# Access Compliance Report

## Public Rights-of-Way

### (Pedestrian Signals)

Intersection ID: N/A	Main Street:	Cross Street: N/A	Location: N/A
ADA ID: FA46889FC719	Signal Type: One Push Button-Non APS	Overall Compliance: No	Severity Score: BTN 1: N/A BTN 2: N/A No BTN: N/A
Codes/Mitigation Info/Possible Solution		Field Measurements/Component Compliance

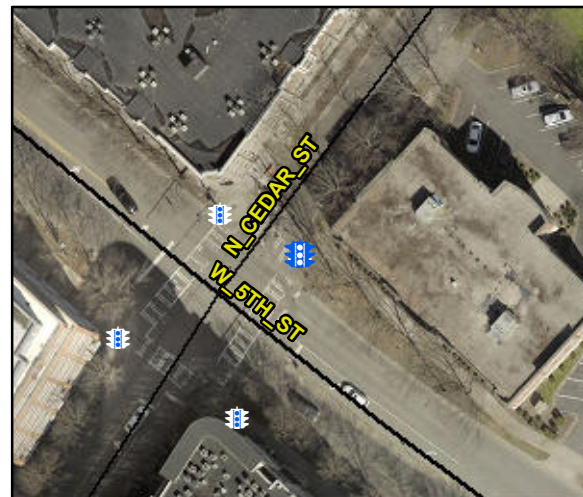
Surveyor Notes: TEXT HT 5/16

PROW/ADA: R410.6, R404.2, R406.2

Possible Solutions: Remove & Replace Sign. Provide Push Button Extension. Remove and Replace Clear Space.
